August 18, 2025

Tucker Ferguson
District Engineer, Austin District
Texas Department of Transportation

I-35 CapEx Central Project

Cross-Section of West Edge of ROW between E 3rd St & E 4th St, Looking North

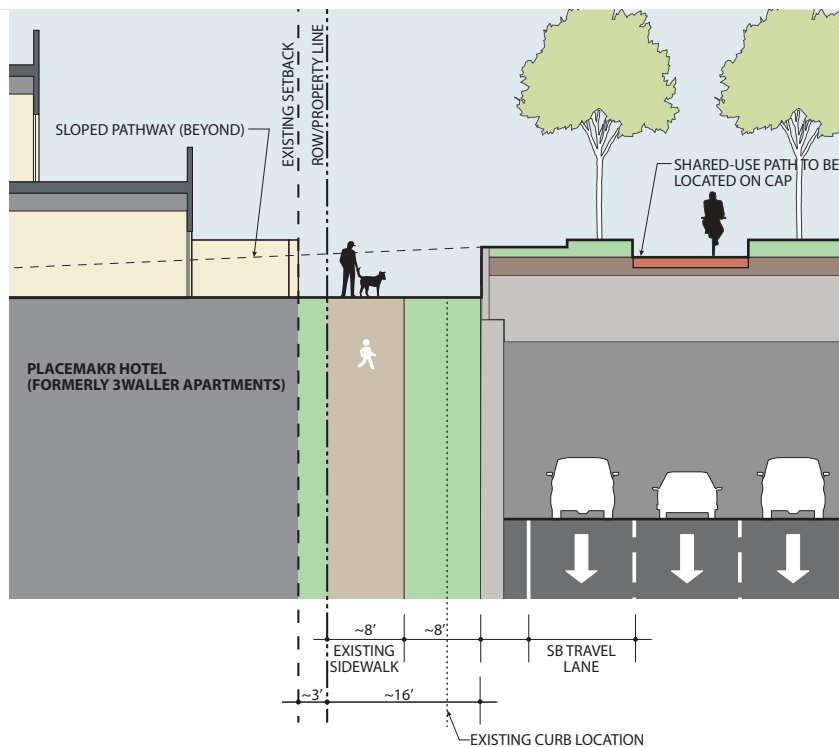
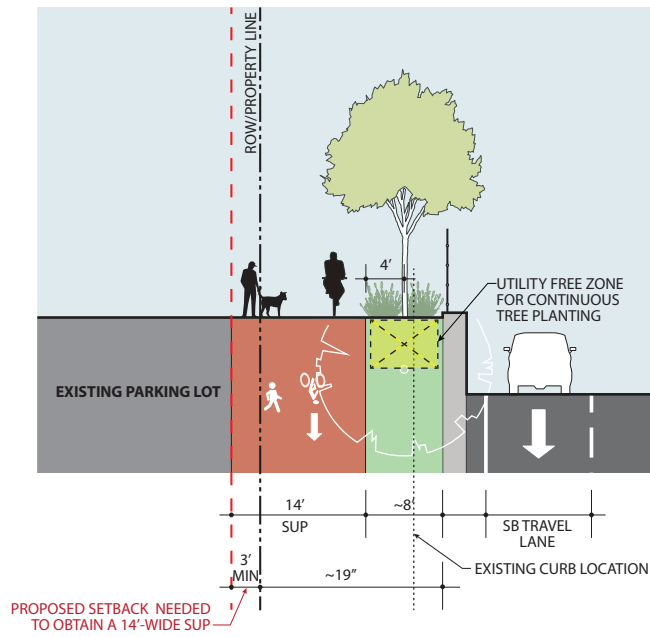
- The TxDOT Design is a cross-sectional depiction of the plan view roll-plots of the 8.5.2025 Design, as posted on the [txdot.gov/mymobility35/projects/capex-central.html](https://www.txdot.gov/mymobility35/projects/capex-central.html) website. As no cross-sections or elevational information were provided, this cross-section is conceptual only.
- A minimum Utility Free Zone of 7' wide X 5' deep is required to allow for shade trees to be planted in a continuous trench, per the Concept Tree Planting Detail found at the end of this package. It is critical to ensure that no underground utilities are located within this zone.
- Trees planted in a continuous trench each require a minimum soil volume of 750 cu ft. Individually-planted trees require a min. soil volume of 1,000 cu ft.

Cross-Section of West Edge of ROW between E 4th St & E 5th St, Looking North

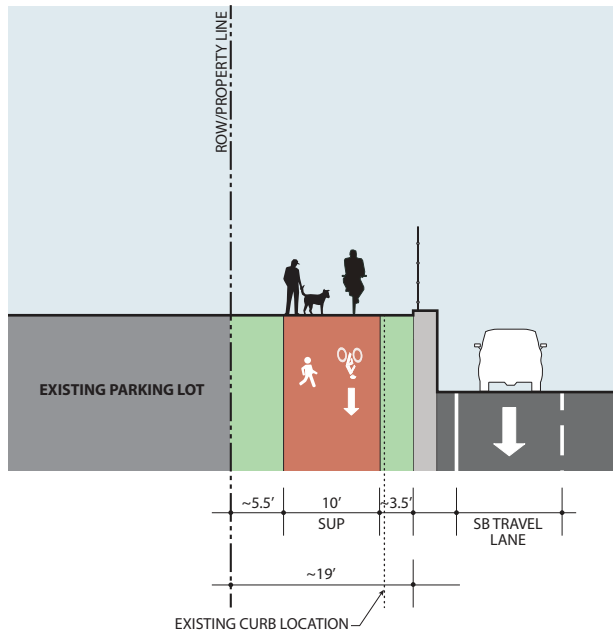
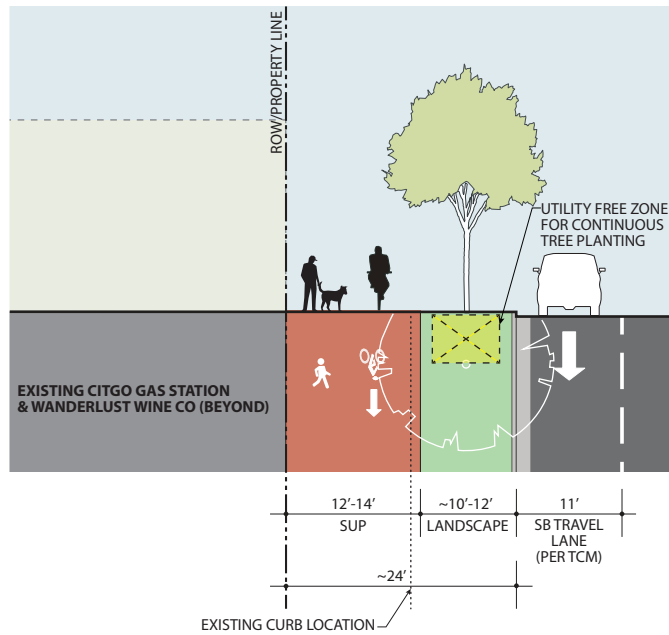
- The TxDOT Design is a cross-sectional depiction of the plan view roll-plots of the 8.5.2025 Design, as posted on the [txdot.gov/mymobility35/projects/capex-central.html](https://www.txdot.gov/mymobility35/projects/capex-central.html) website. As no cross-sections or elevational information were provided, this cross-section is conceptual only.
- A minimum Utility Free Zone of 7' wide X 5' deep is required to allow for shade trees to be planted in a continuous trench, per the Concept Tree Planting Detail found at the end of this package. It is critical to ensure that no underground utilities are located within this zone.
- Trees planted in a continuous trench each require a minimum soil volume of 750 cu ft. Individually-planted trees require a min. soil volume of 1,000 cu ft.

Cross-Section of West Edge of ROW between E 6th St & E 7th St, Looking North

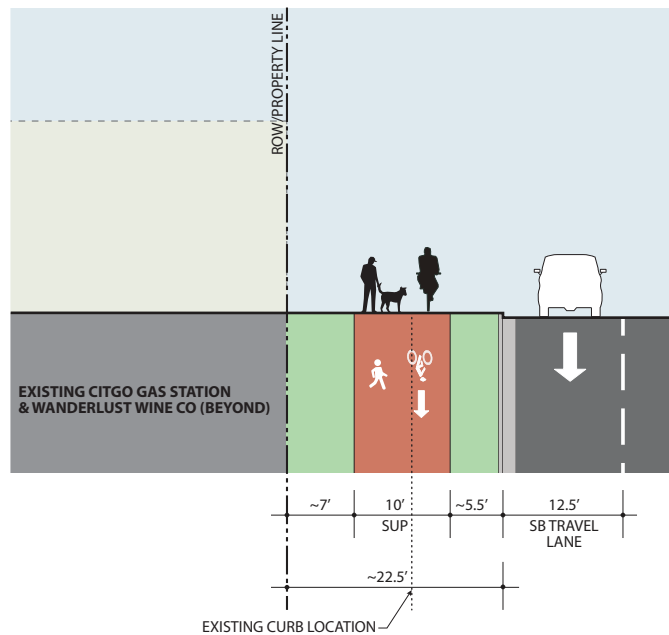
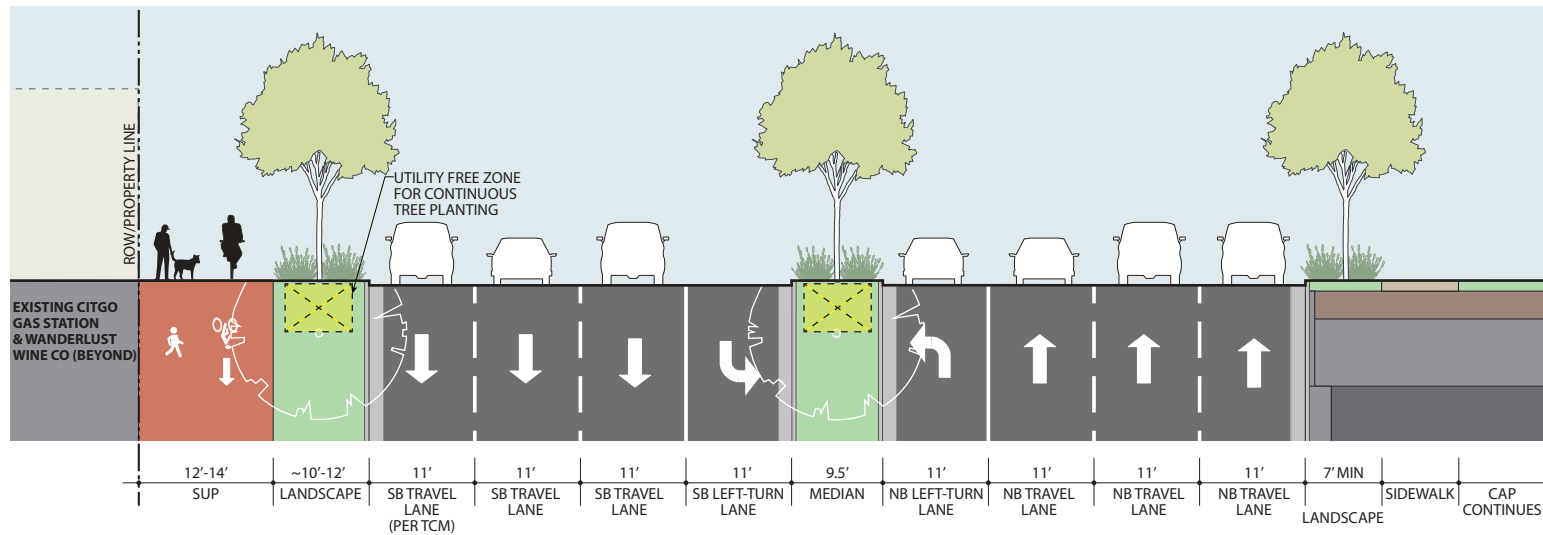
- The TxDOT Design is a cross-sectional depiction of the plan view roll-plots of the 8.5.2025 Design, as posted on the [txdot.gov/mymobility35/projects/capex-central.html](https://www.txdot.gov/mymobility35/projects/capex-central.html) website. As no cross-sections or elevational information were provided, this cross-section is conceptual only.
- A minimum Utility Free Zone of 7' wide X 5' deep is required to allow for shade trees to be planted in a continuous trench, per the Concept Tree Planting Detail found at the end of this package. It is critical to ensure that no underground utilities are located within this zone.
- Trees planted in a continuous trench each require a minimum soil volume of 750 cu ft. Individually-planted trees require a min. soil volume of 1,000 cu ft.

Cross-Section of Frontage Road between E 6th St & E 7th St at Mid-Block, Looking North

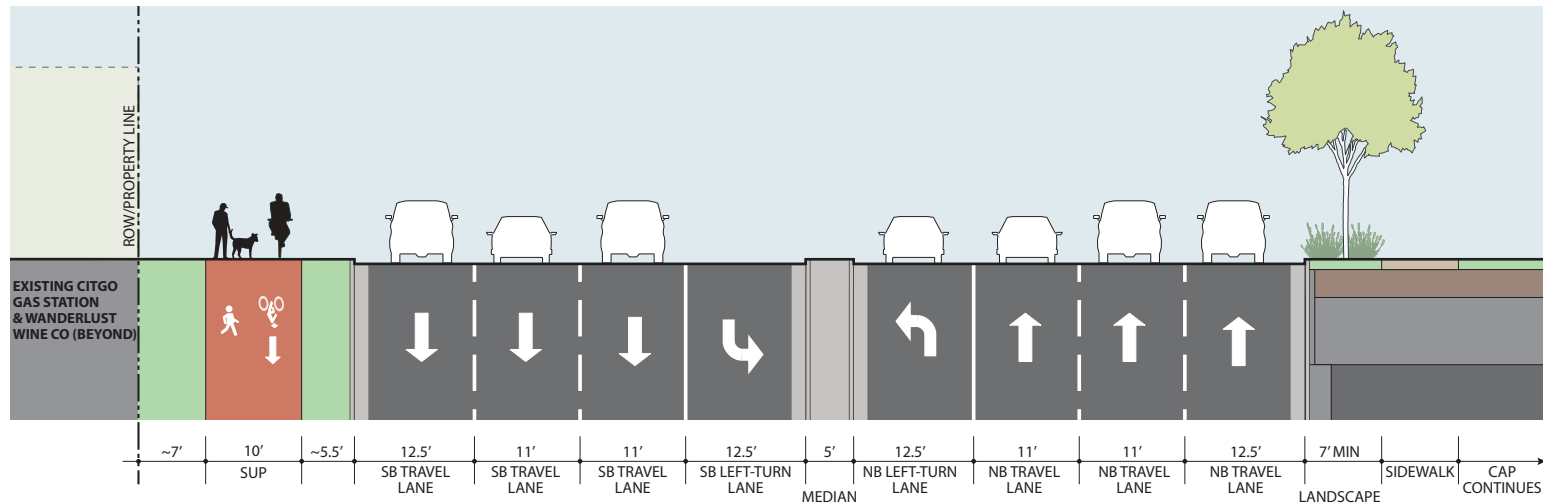
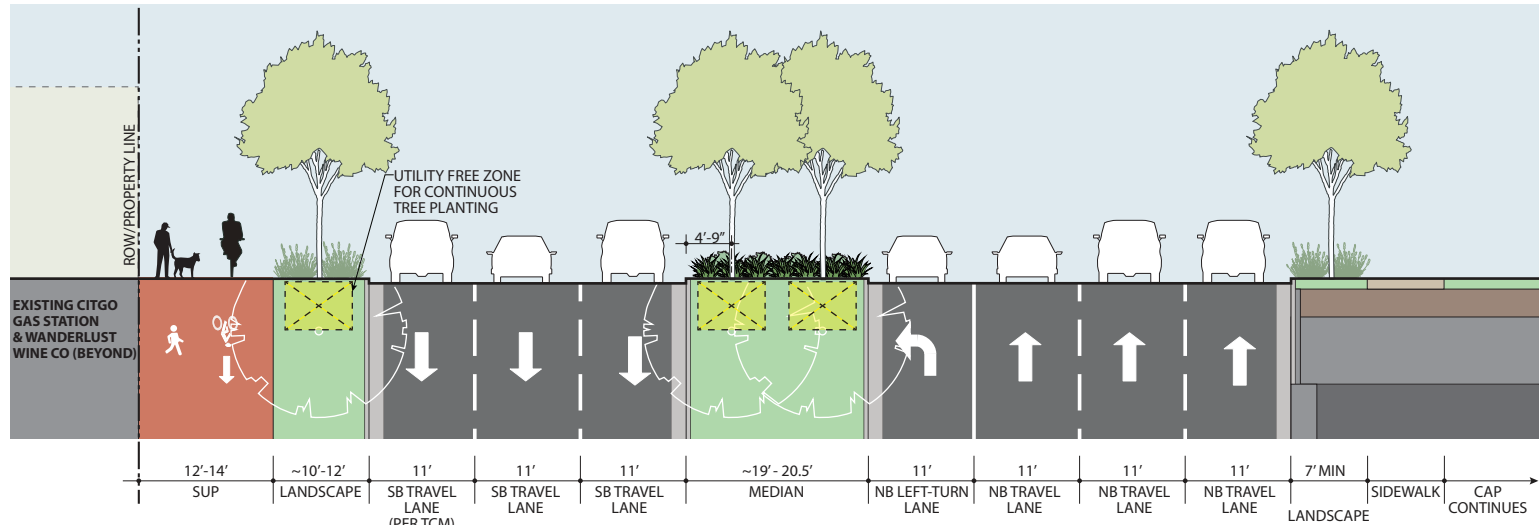
- The TxDOT Design is a cross-sectional depiction of the plan view roll-plots of the 8.5.2025 Design, as posted on the [txdot.gov/mymobility35/projects/capex-central.html](https://www.txdot.gov/mymobility35/projects/capex-central.html) website. As no cross-sections or elevational information were provided, this cross-section is conceptual only.
- A minimum Utility Free Zone of 7' wide X 5' deep is required to allow for shade trees to be planted in a continuous trench, per the Concept Tree Planting Detail found at the end of this package. It is critical to ensure that no underground utilities are located within this zone.
- Trees planted in a continuous trench each require a minimum soil volume of 750 cu ft. Individually-planted trees require a min. soil volume of 1,000 cu ft.

Cross-Section of Frontage Road between E 6th St & E 7th St at Intersection, Looking North

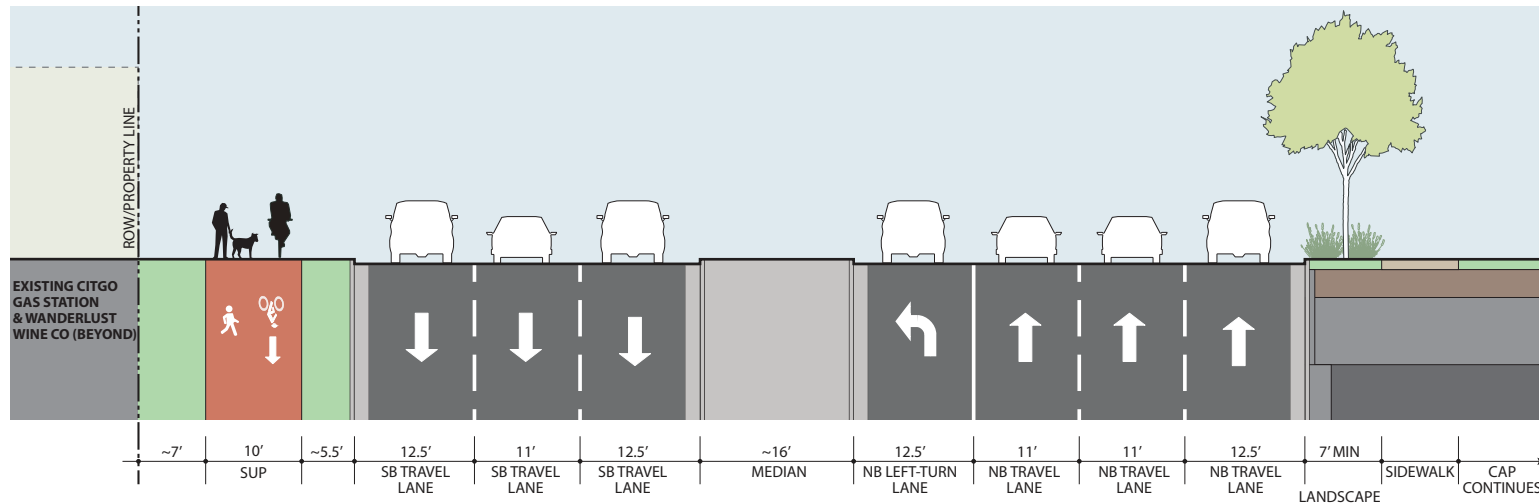
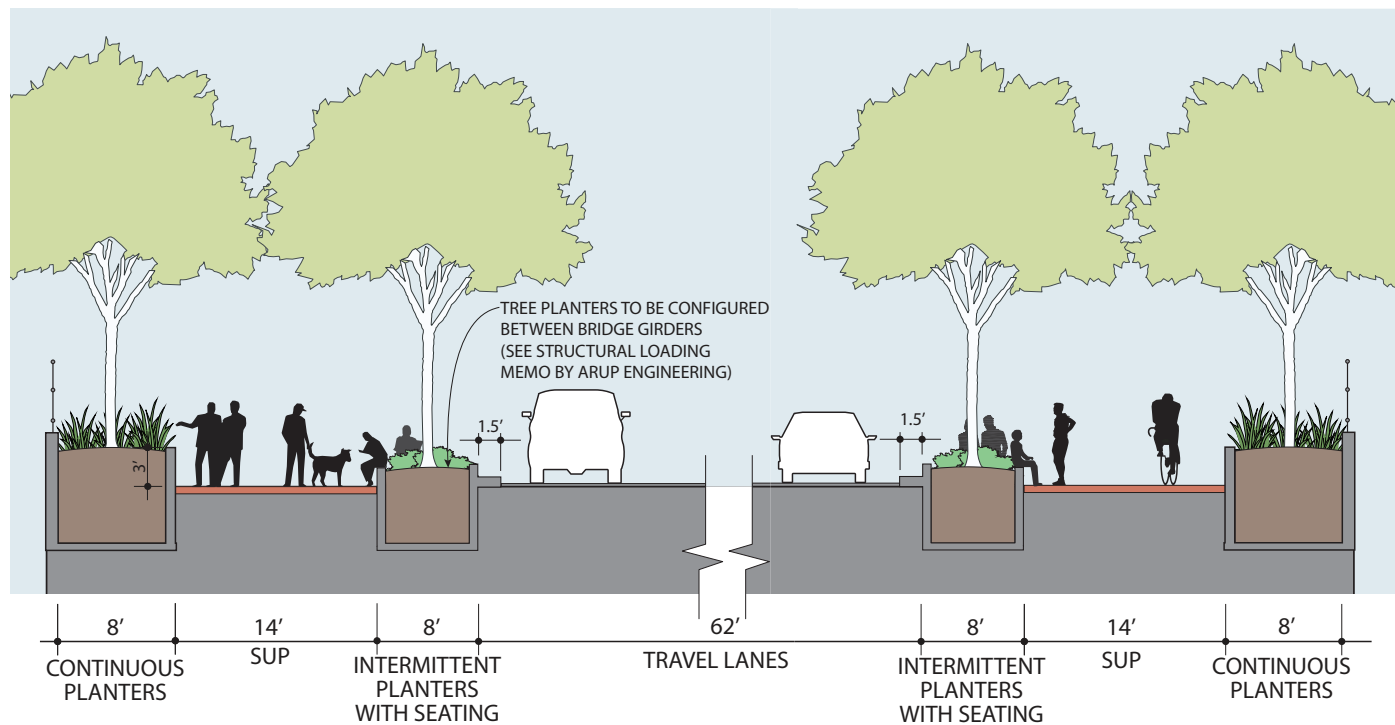
- The TxDOT Design is a cross-sectional depiction of the plan view roll-plots of the 8.5.2025 Design, as posted on the [txdot.gov/mymobility35/projects/capex-central.html](https://www.txdot.gov/mymobility35/projects/capex-central.html) website. As no cross-sections or elevational information were provided, this cross-section is conceptual only.
- A minimum Utility Free Zone of 7' wide X 5' deep is required to allow for shade trees to be planted in a continuous trench, per the Concept Tree Planting Detail found at the end of this package. It is critical to ensure that no underground utilities are located within this zone.
- Trees planted in a continuous trench each require a minimum soil volume of 750 cu ft. Individually-planted trees require a min. soil volume of 1,000 cu ft.

Cross-Section through E Cesar Chavez St Bridge, Looking West

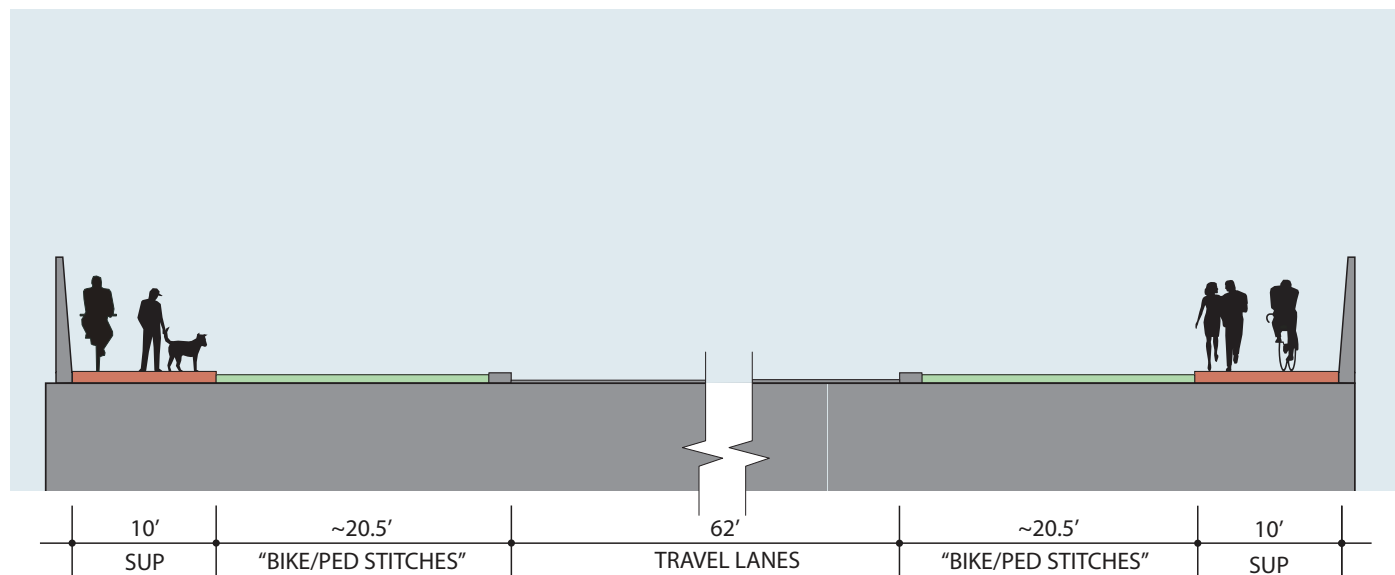
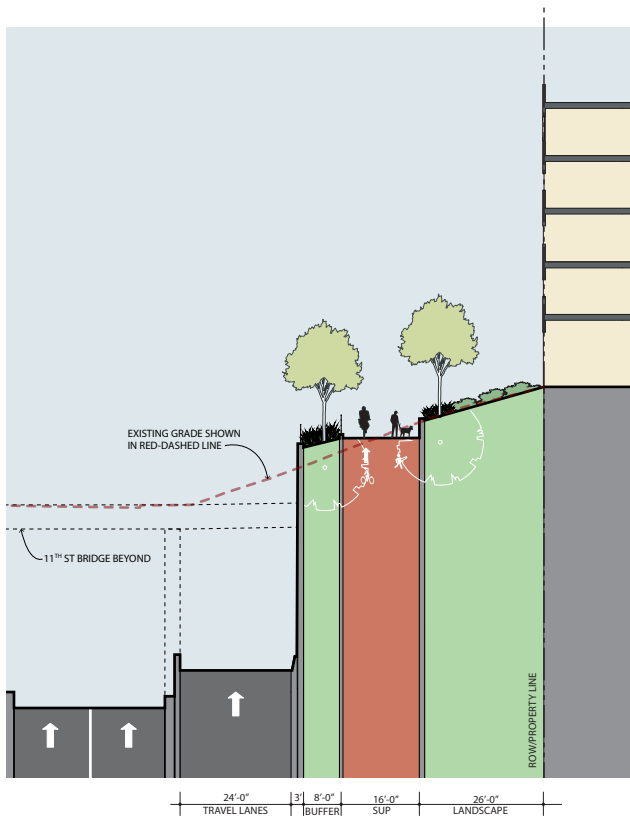
We appreciate the new TxDOT design standards that require 30 feet back-of-curb for shared use paths and planting zones on bridges. We understand from one of the studies that the City's engineering consultant provided, that inserting full-depth tree planters is entirely feasible, as these may be inserted between the structural girders of the bridge. It is important to achieve enough depth and volume of soil to sustain healthy shade trees. Living trees, and the shade they provide, will be critical for comfort and air quality on bridges. Please ensure that all bridges have trees, spaced 20 to 25 feet apart, to create a continuous shade canopy.

- The TxDOT Design is a cross-sectional depiction of the plan view roll-plots of the 8.5.2025 Design, as posted on the [txdot.gov/mymobility35/projects/capex-central.html](https://www.txdot.gov/mymobility35/projects/capex-central.html) website. As no cross-sections or elevational information were provided, this cross-section is conceptual only.
- Trees planted in a continuous trench each require a minimum soil volume of 750 cu ft. Individually-planted trees require a min. soil volume of 1,000 cu ft.

Cross-Section of East Avenue Trail at E 10 St, Looking North

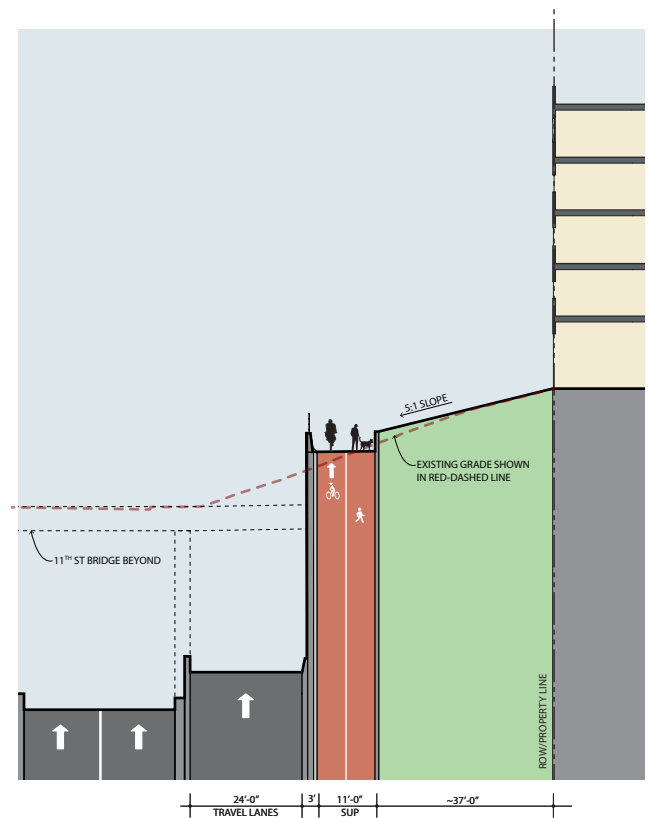
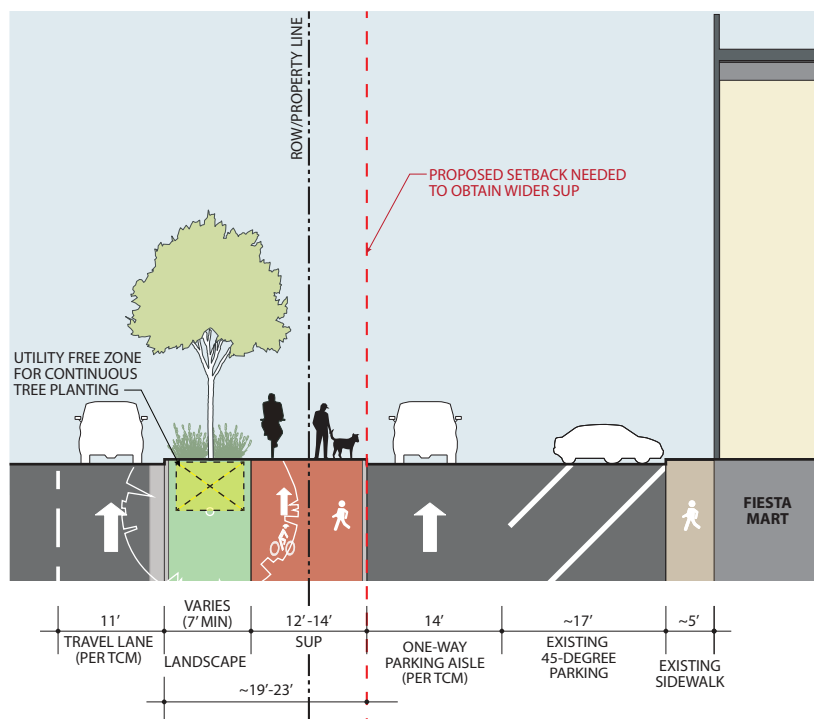
- The TxDOT Design is a cross-sectional depiction of the plan view roll-plots of the 8.5.2025 Design, as posted on the [txdot.gov/mymobility35/projects/capex-central.html](https://www.txdot.gov/mymobility35/projects/capex-central.html) website. As no cross-sections or elevational information were provided, this cross-section is conceptual only.
- A minimum Utility Free Zone of 7' wide X 5' deep is required to allow for shade trees to be planted in a continuous trench, per the Concept Tree Planting Detail found at the end of this package. It is critical to ensure that no underground utilities are located within this zone.
- Trees planted in a continuous trench each require a minimum soil volume of 750 cu ft. Individually-planted trees require a min. soil volume of 1,000 cu ft.
